ZONING BOARD OF APPEALS MEETING
LOCATION: TOWNSHIP ANNEX, 7527 HIGHLAND ROAD, WHITE LAKE, MICHIGAN 48383
THURSDAY, APRIL 24, 2025 – 6:30 PM

AGENDA

TO: Zoning Board of Appeals
FROM: Andrew Littman, Staff Planner
DATE: April 14, 2025

PRELIMINARY/FINAL SITE PLANS FOR:
WHITE LAKE MOTORS
MICHIGAN AUTOMOTIVE GROUP
CHARTER TOWNSHIP OF WHITE LAKE, OAKLAND COUNTY, MICHIGAN

SHEET
C-3

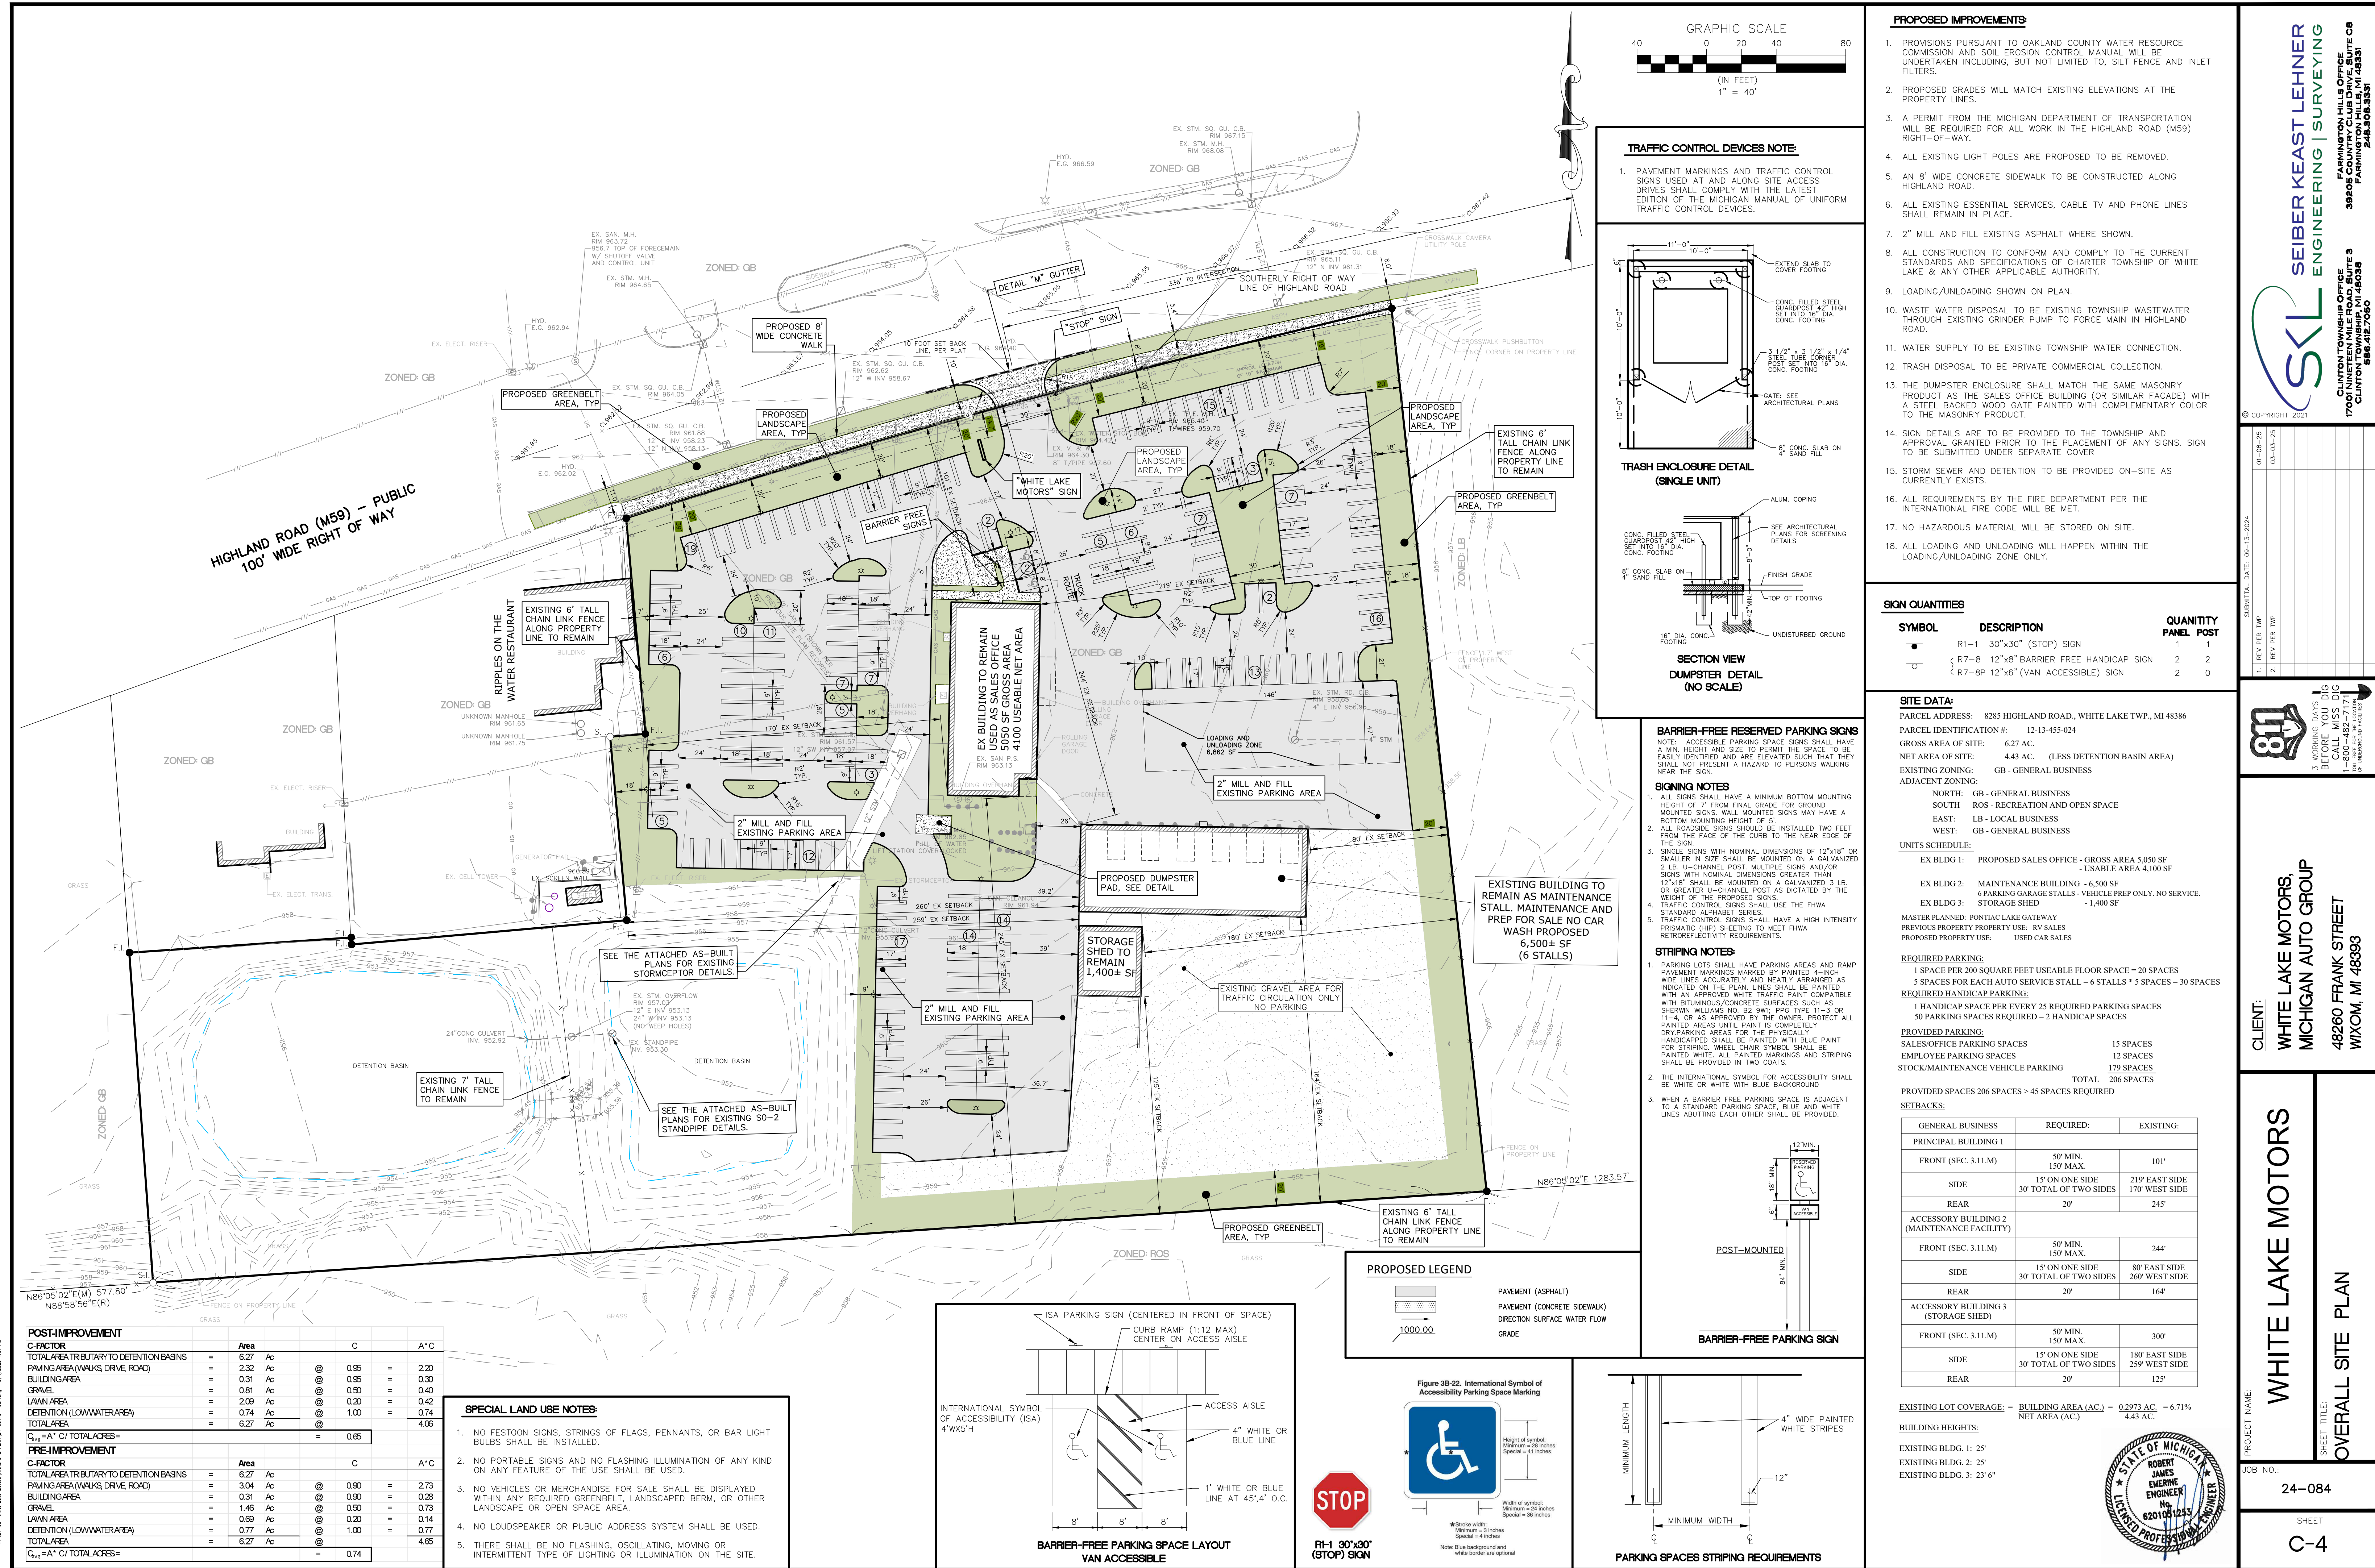
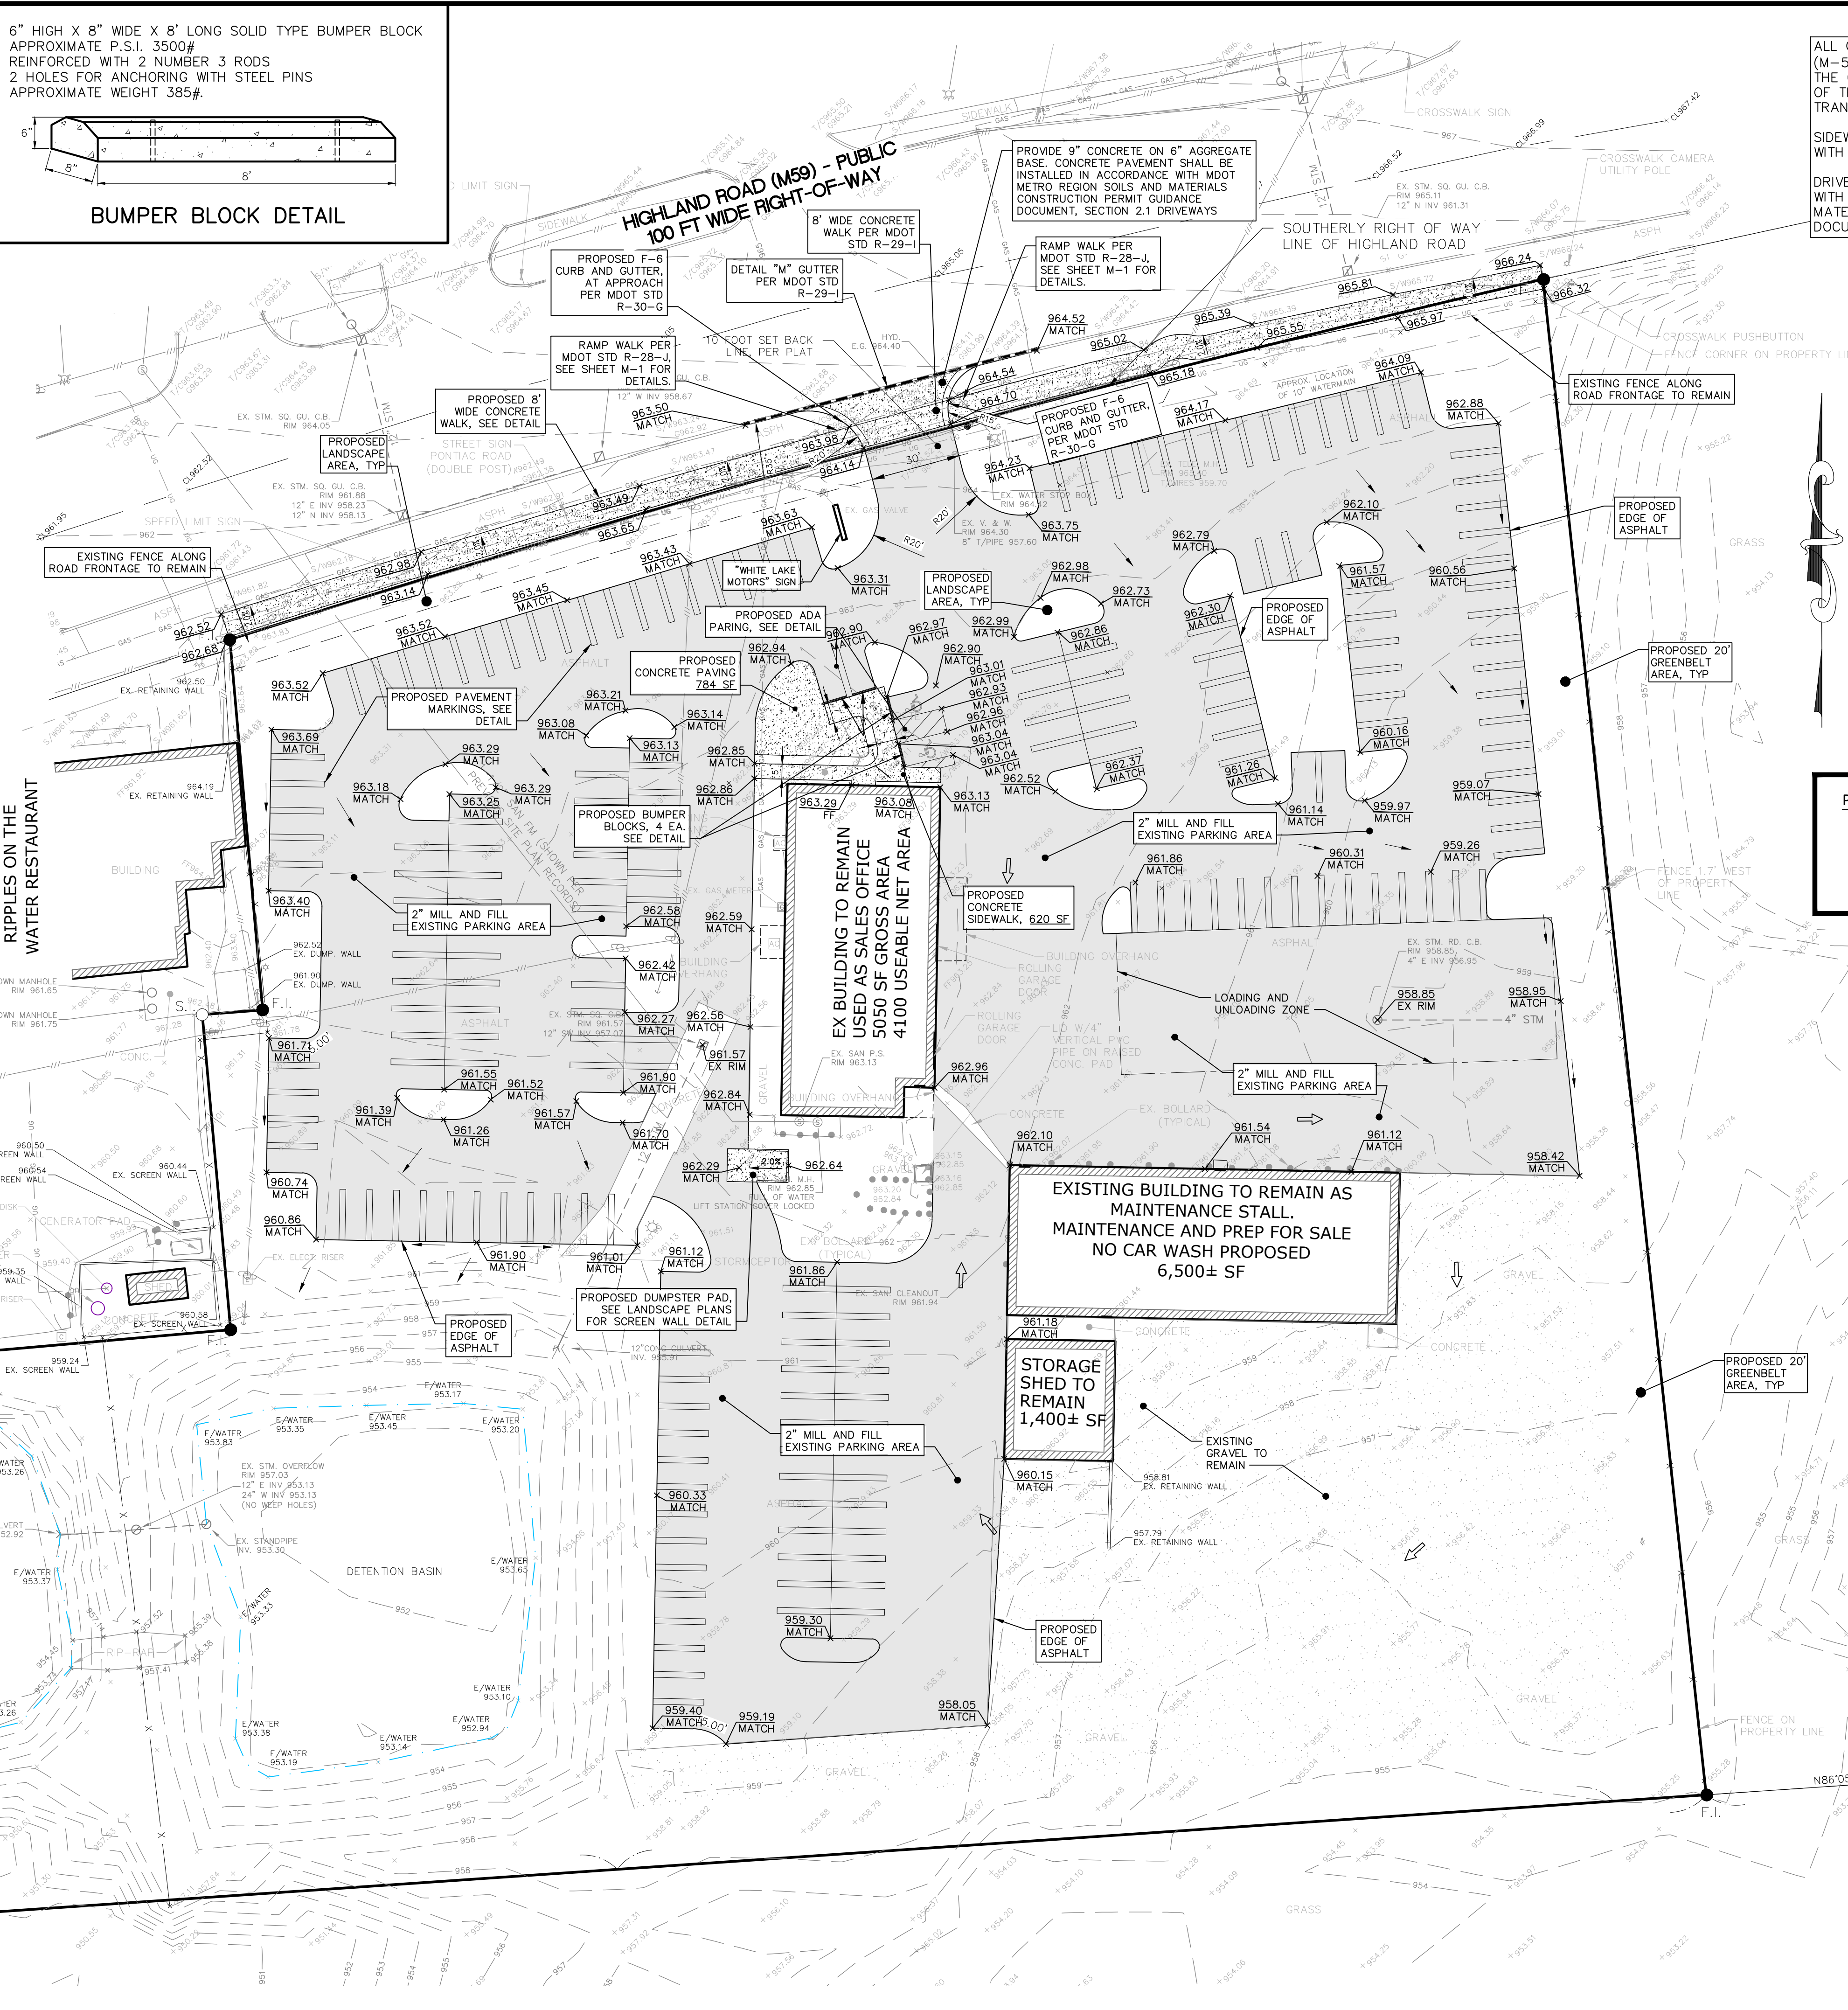
The demolition plan on Sheet C-3 indicates that the site will retain the perimeter fences, concrete storm drain, utility poles and the gravel surface in the southeast corner of the site. Sheet C-4 states the gravel area will be used for traffic circulation only. No parking will be permitted in this area. The majority of the site's asphalt and concrete infrastructure will be demolished and redone under a new layout better suited to meet operational needs and zoning standards.

Fence standards are outlined in Section 5.12. Sheet C-3 indicates the perimeter fencing is to remain. A five (5) foot tall black iron fence is proposed to remain along the Highland Road (M-59) frontage. Existing six (6) foot high chain link fence is along the east, south, and west perimeter. All fence heights and materials are compliant with current standards. We recommend the front property line fence be removed to improve aesthetics of the site and intent of the gateway area.
